## For Thursday meeting

PLAN:  
2ND FLOOR  
BATH 2  
BATH 3

PHIL & MICHELLE WOOD  
3435 N. 140TH. CIRCLE  
OMAHA, NE 68164

PRIMARY WARDROBE  
SCALE: 1/2" = 1'-0"

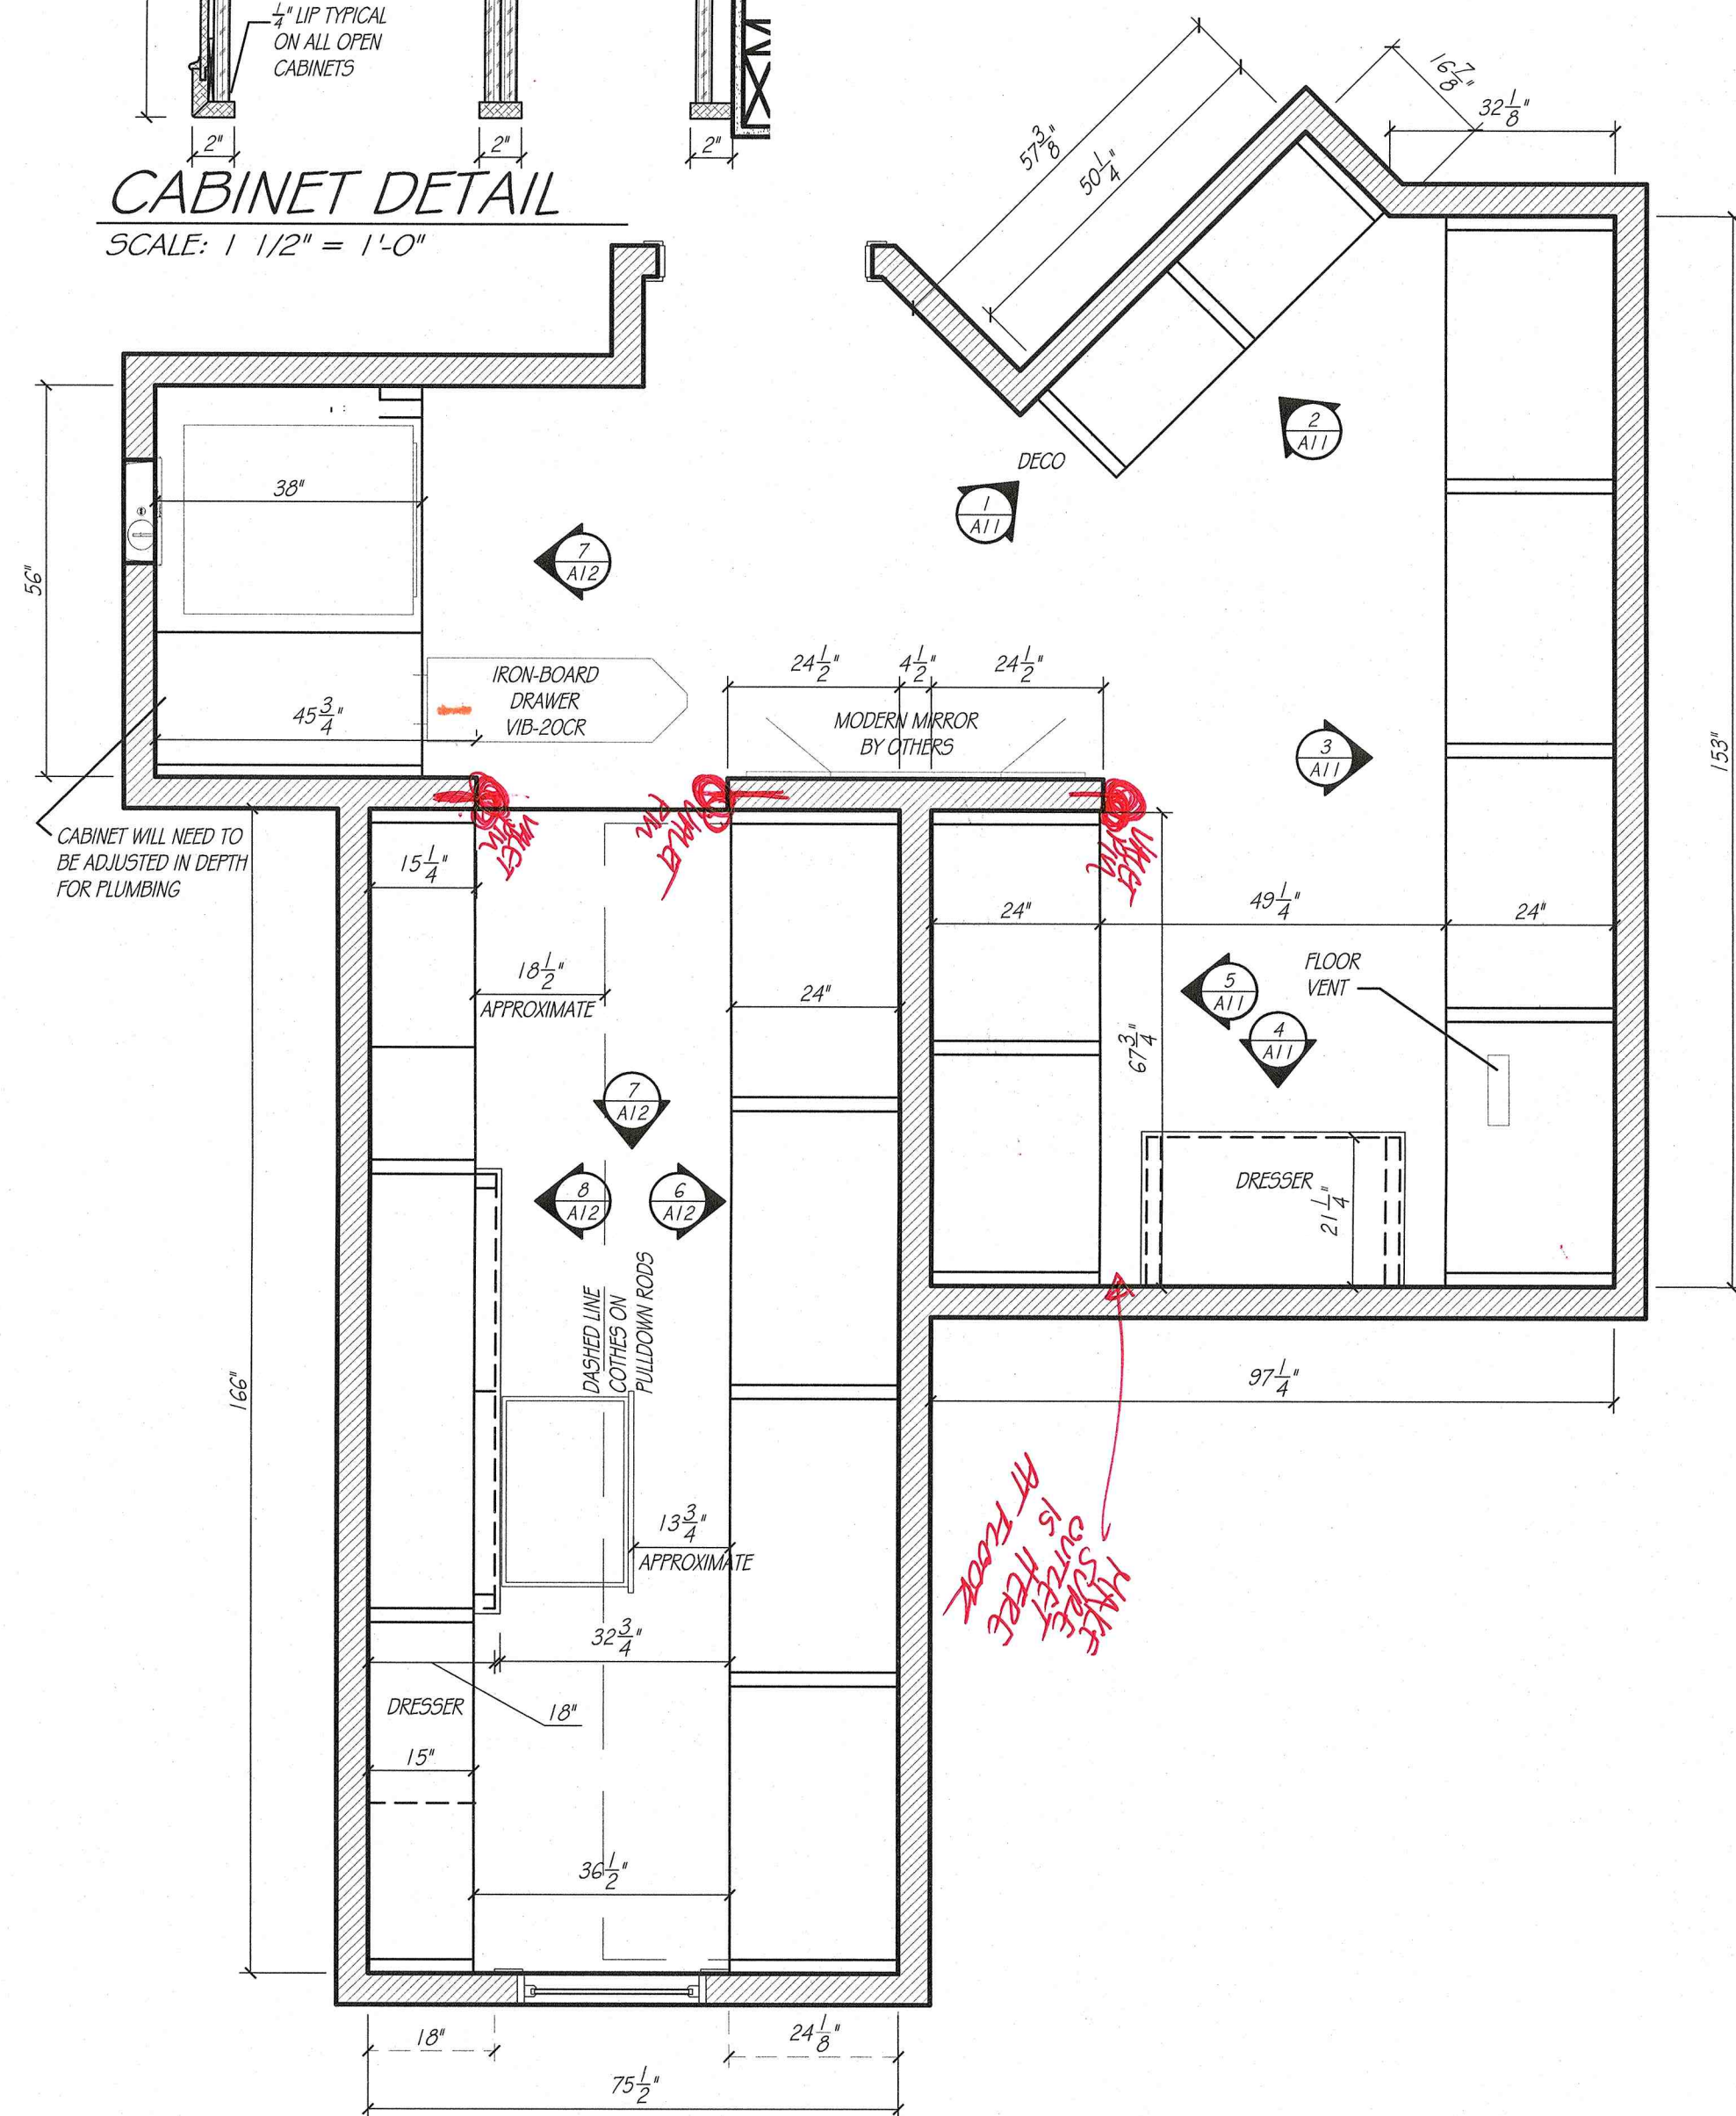
- Outlet above floor is currently where the dresser will go so it will need to be moved to either side.
- Michelle's closet -
  - Furniture toe under dresser or is it already decorative?

- Flat drawer fronts on jewelry drawers, decorative edge?
  - Need more hanging space on the two lower sections on left when walking into her closet (bars not spaced far enough apart to hang normal clothes). Need at least 32-34" in between each to allow proper hanging. Would removing shelves on top of the bars give us the space? Or, can we reduce the height of the motorized spaces above a bit?

- Ensure depth of "fancy" cabinetry is same depth. Plan shows 15" deep on the entrance side and 15 1/4" on the window side of her dresser.
  - Need to see belt holder, scarf holder, and other accessories so we can choose.

feature the w/ recess door (switch this door)

contact on site for LDD info to install (switch for use)

| PLAN:      | LAUNDRY                                                                      |

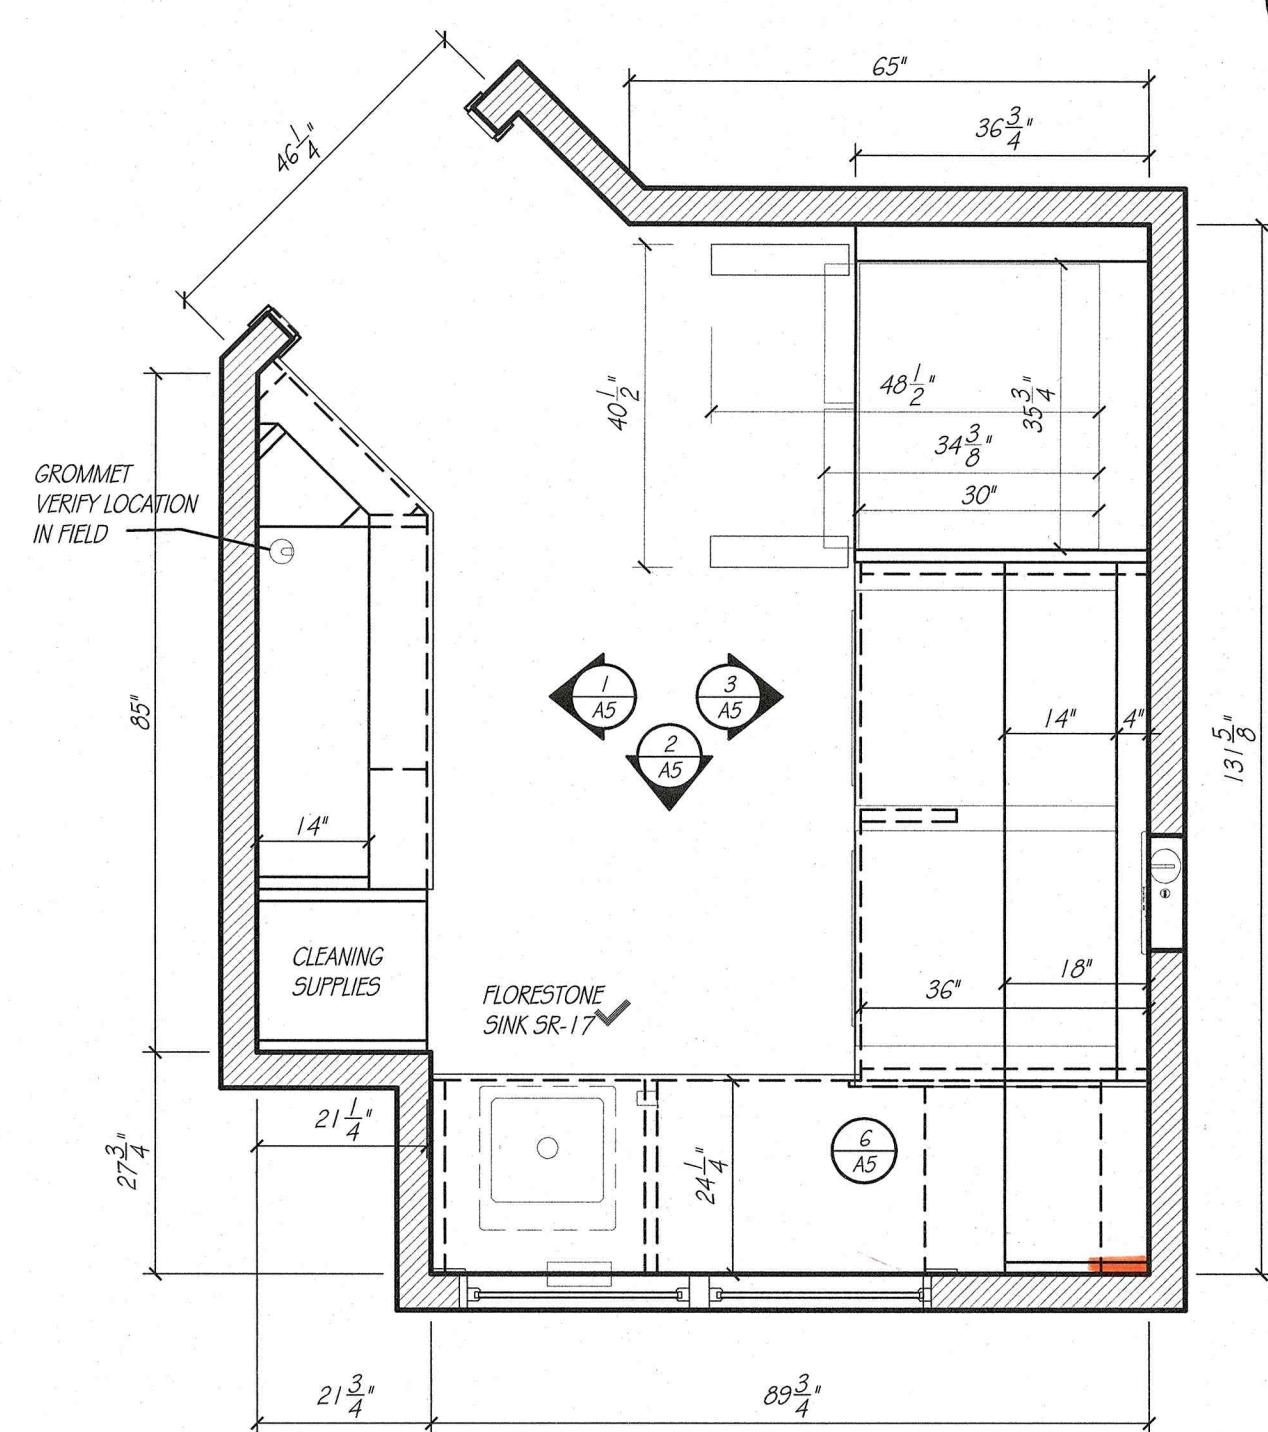
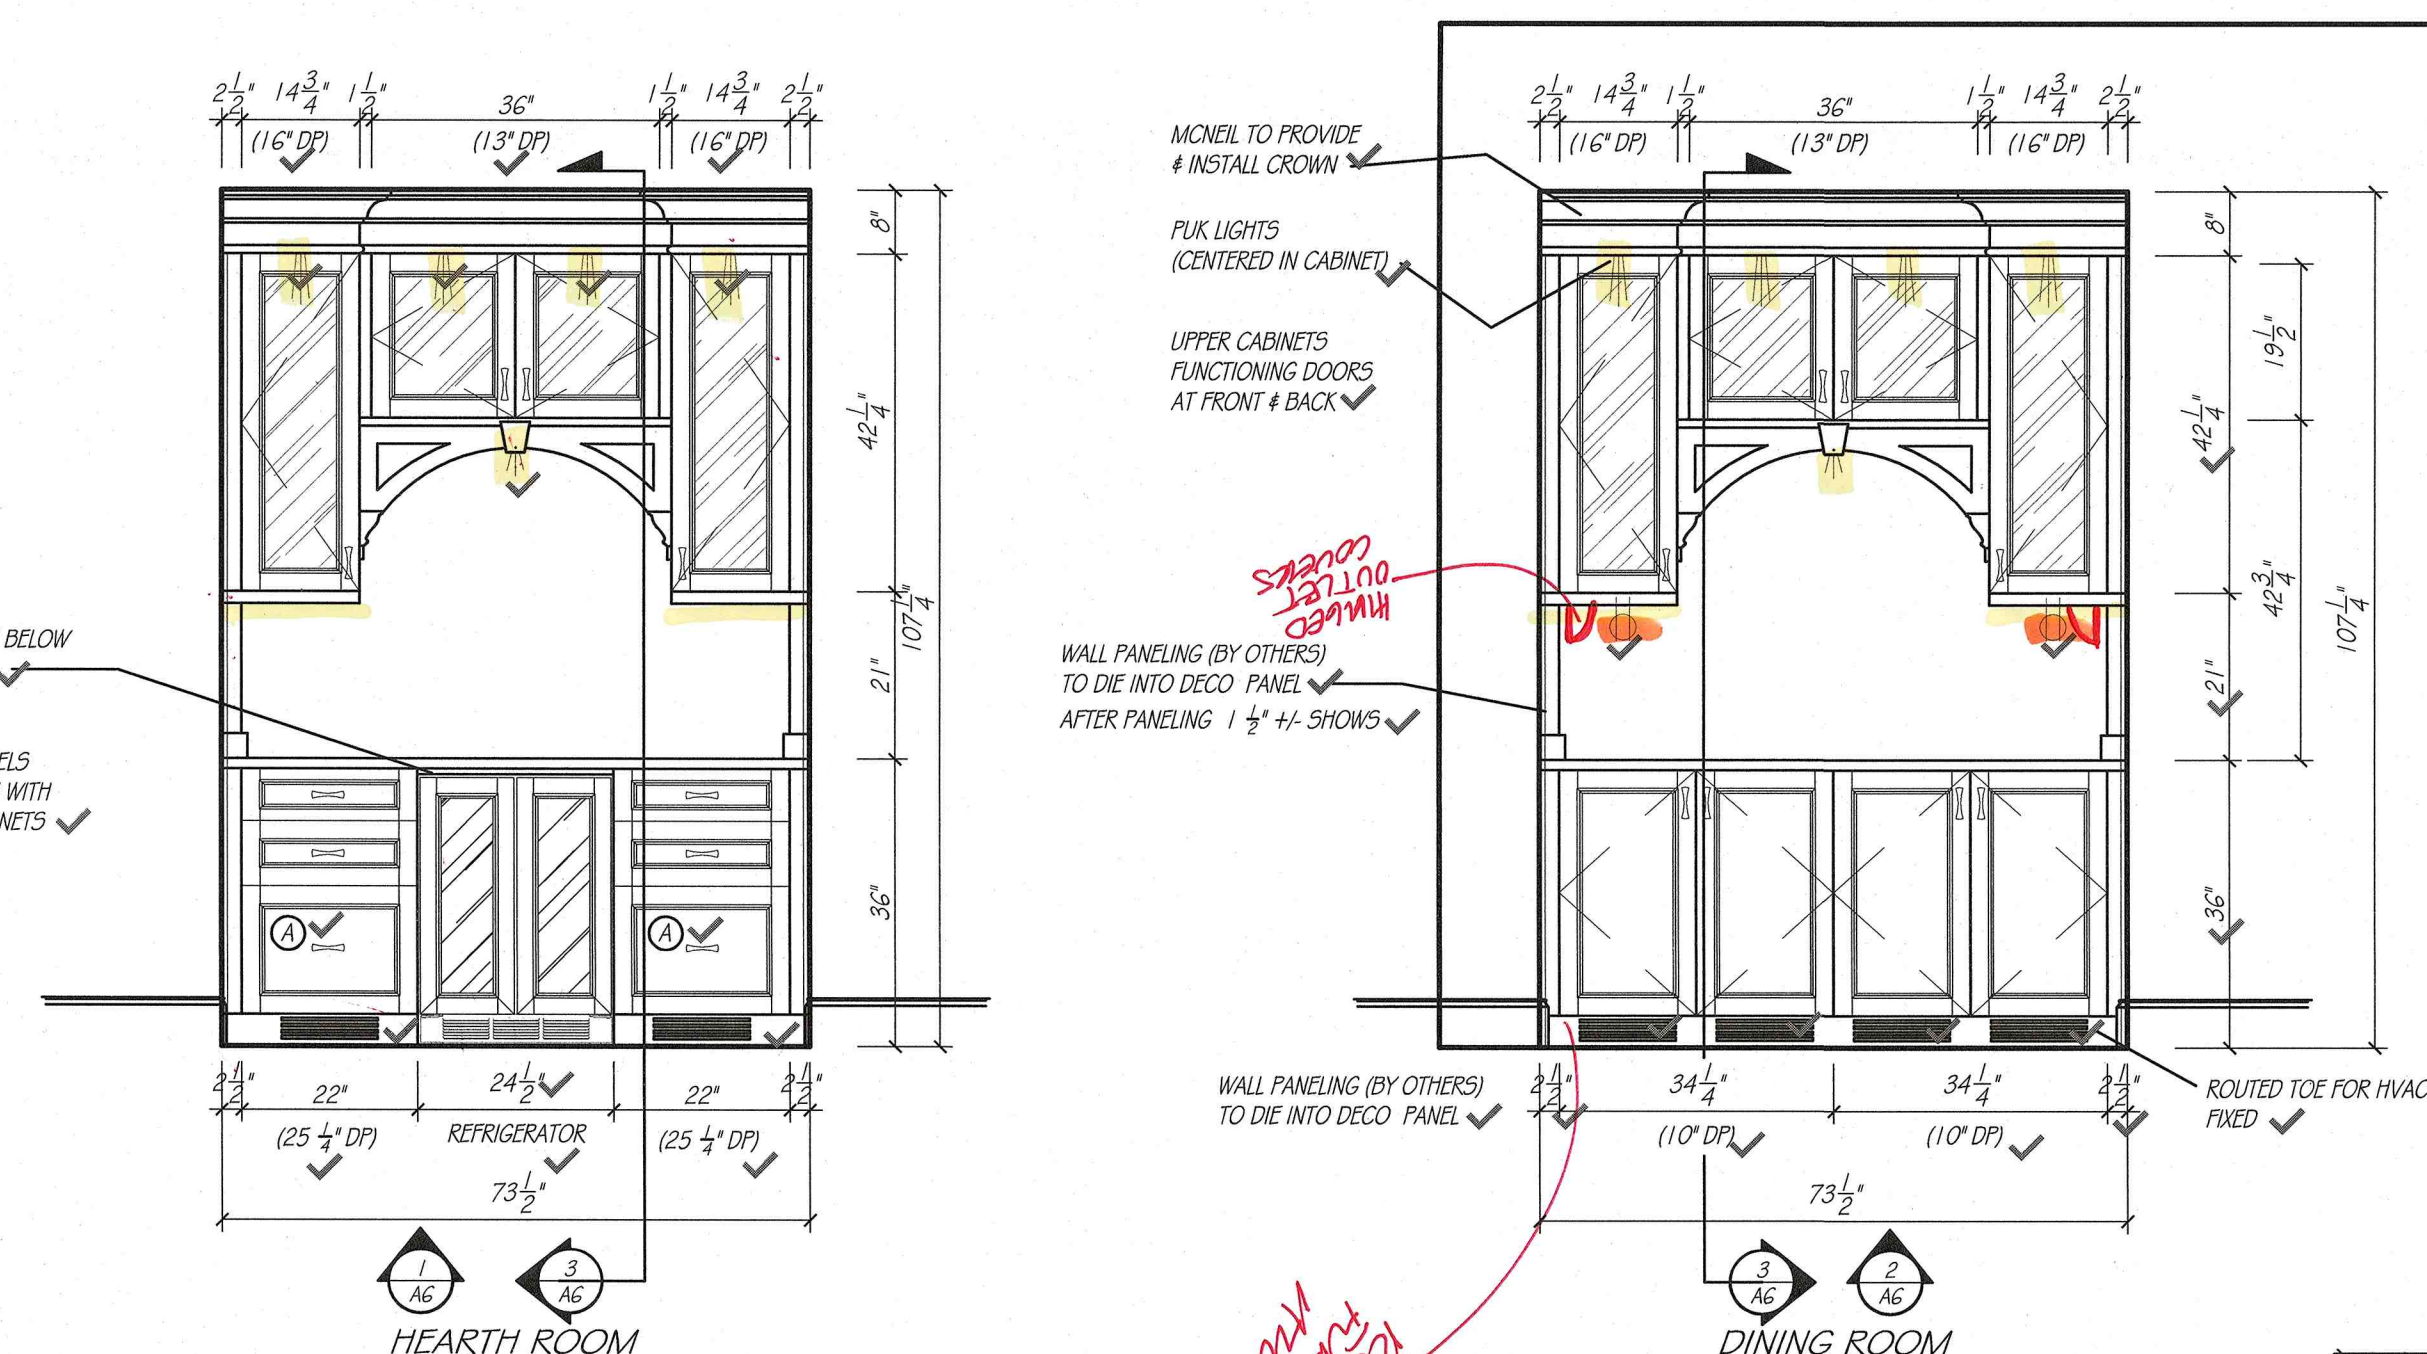
- Laundry -
  - you are increasing the depth of the appliance area by two inches to 39". Since the walkway space in there is limited as it stands, can some of the plumbing/pipework be moved into the wall (similar to new master closet plumbing) to save space in the room?
